RE: October 31, 2000 fax to Cubic Communications, Inc., Mr. Clive Winkler
FCC ID: NVSMTC-100TMCPA

Re: Application dated 10/11/00 and granted 10/31/00
Applicant Name: Cubic Communications Inc
Equipment Class: TNB-Licensed Non-Broadcast Station Transmitter
FCC ID: NVSMTC-100TMCPA

Under the authority of Section 1.113 of the Commission's Rules, the above referenced Grant of Equipment Authorization is hereby SET ASIDE.

SPAN 50.0 kHz
SWP 1.50 sec

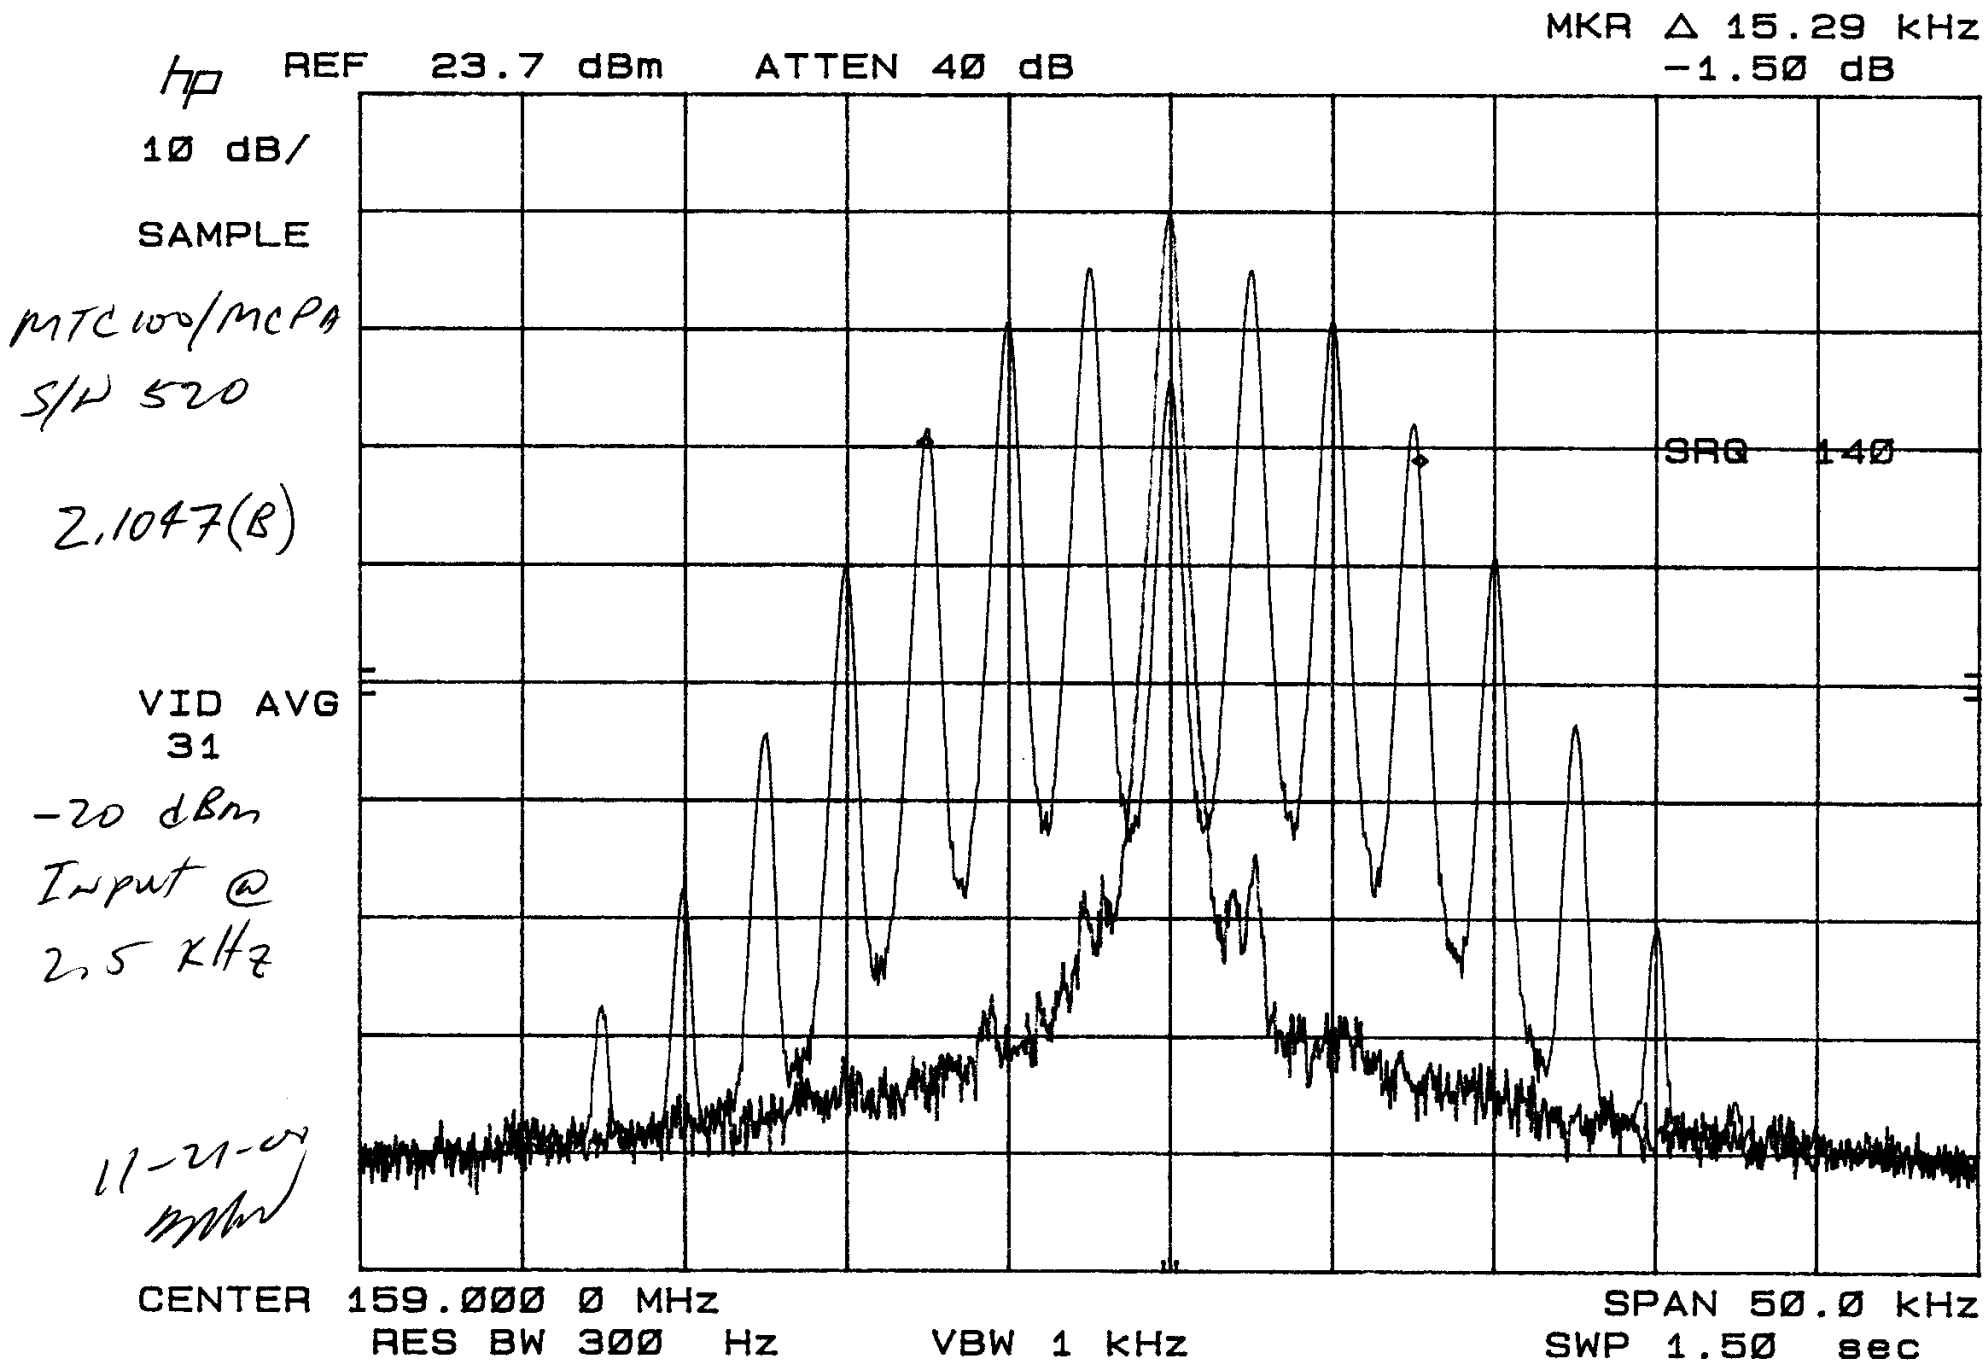
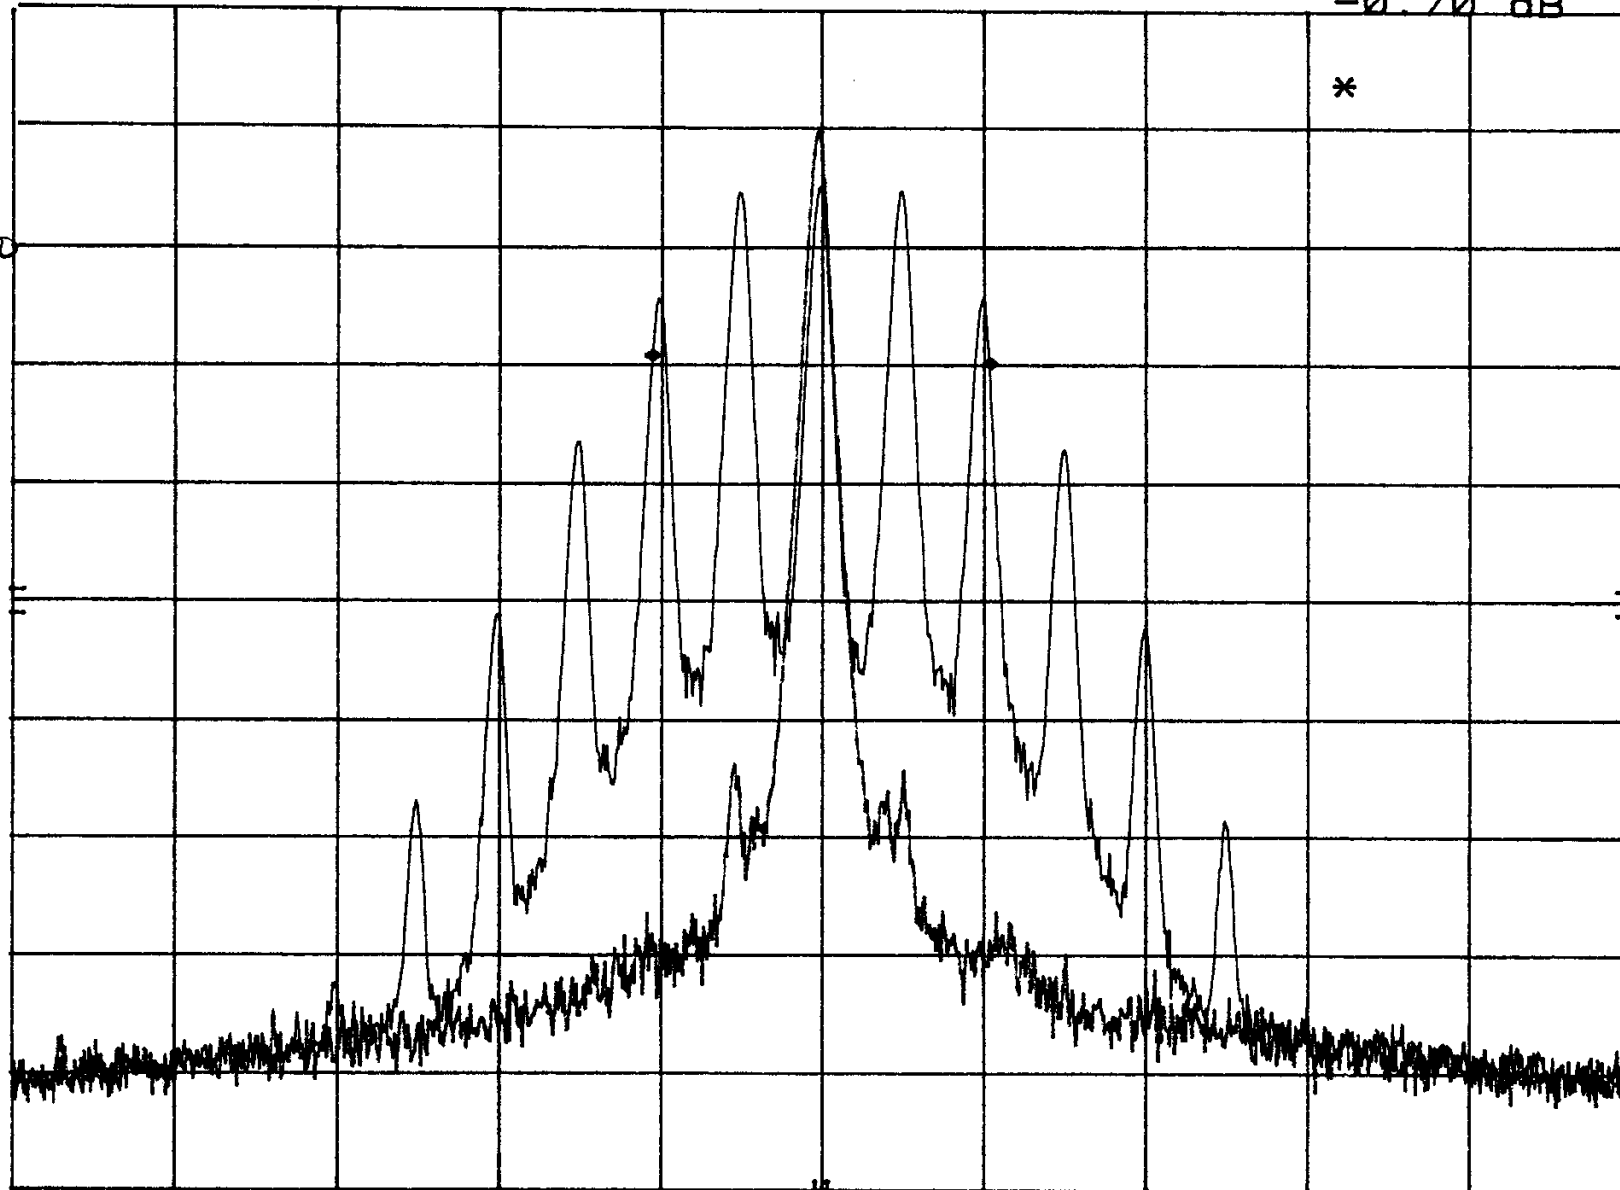
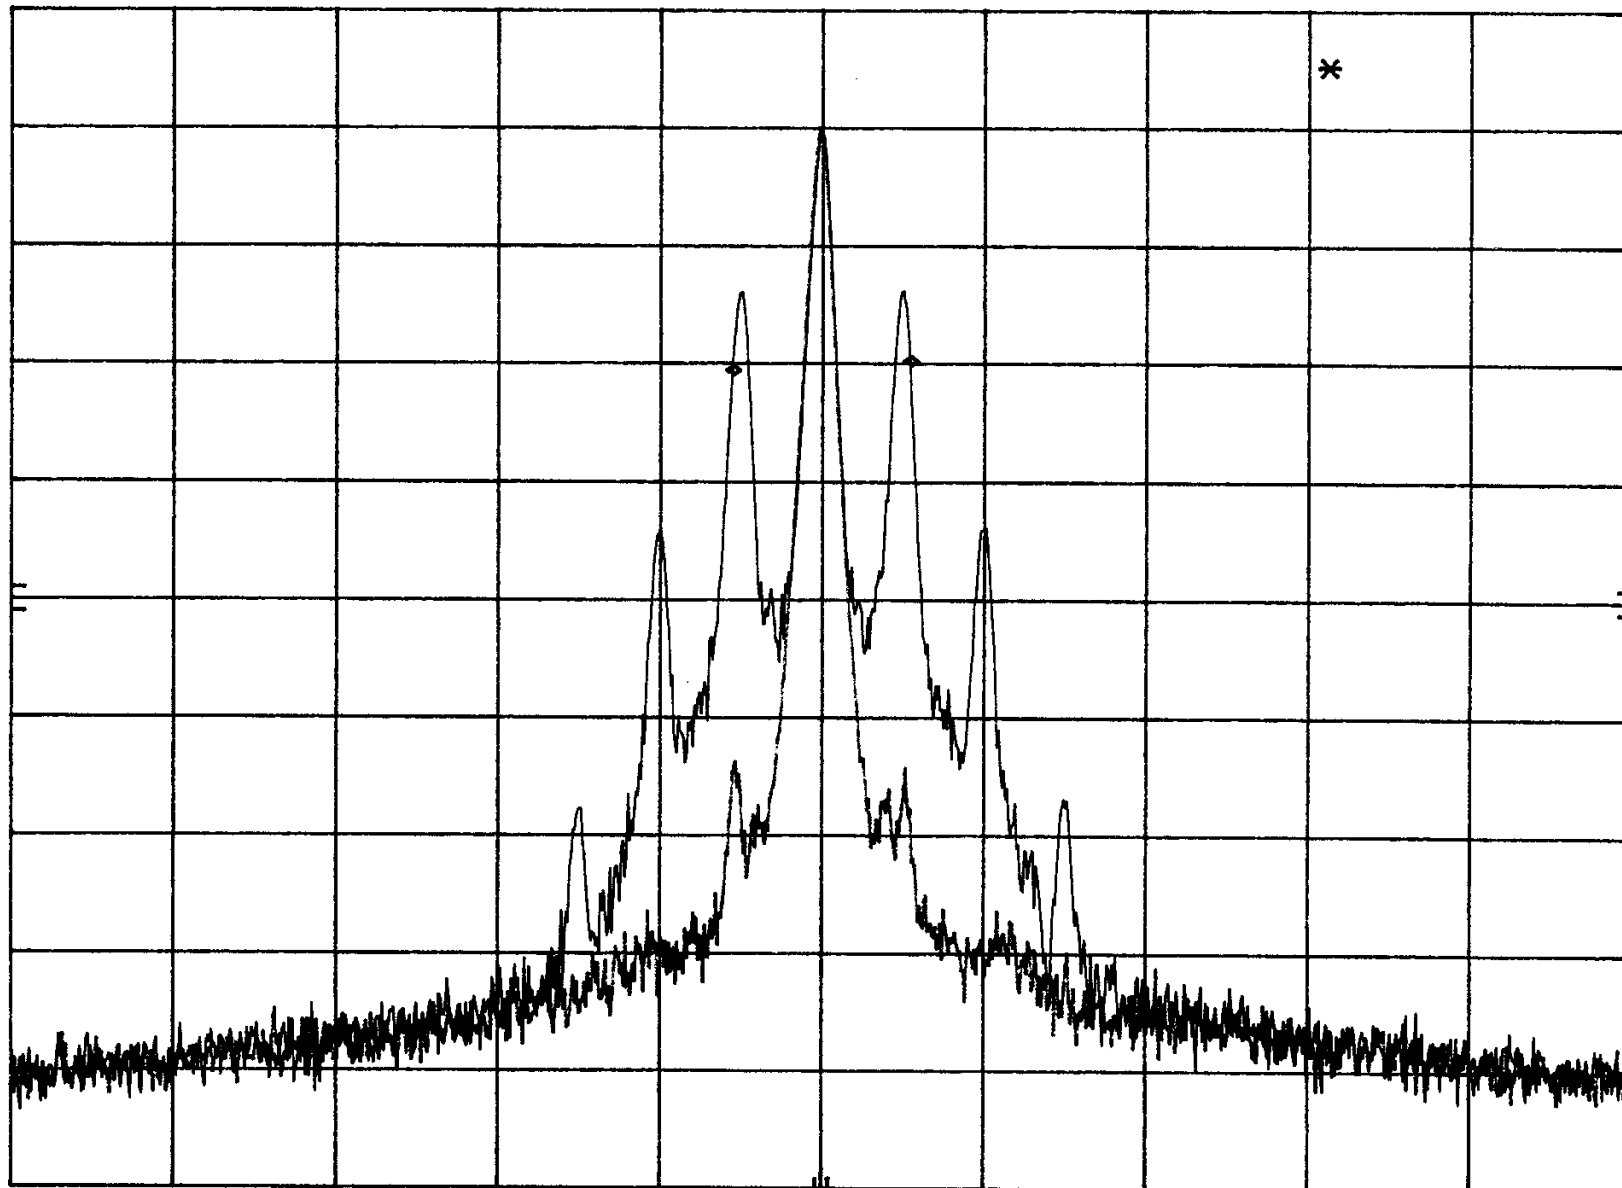
1. Modulation limiting data required by Section 2.1047(b) of the FCC Rules was not submitted.
2. The occupied bandwidth test was not made with the 2500 Hz tone prescribed by Section 2.1049(c)(1) the Rules.
3. No response to the audio low-pass filter requirement of Section 80.213(e) was given.
4. No response to the frequency selection capability of Section 80.203 was given.
5. No response to the DSC requirement under Section 80.203(n) and 80.225 was given.
6. For your information - Please note that the attenuation requirement for unmodulated spurious emissions is prescribed as $43 + 10\log(P)$. This is referenced to the desired signal yielding a level referenced to the carrier or dBc. The attenuation specification is not a specified field strength level or $\mu V/M$. The dBc is determined from the substitution method as described in the ANSI/TIA/EIA-603-1992 document.

“Modulation limiting data required by Section 2.1047(b) of the FCC Rules was not submitted.”

We have attached measured data taken on 11/21/00 according to this specification.

See page 4 for the plot of the data and pages 5 through 11

16	15.29
10	15.34
0	15.29
-10	15.29
-20	15.29
-30	10.45
-40	5.50
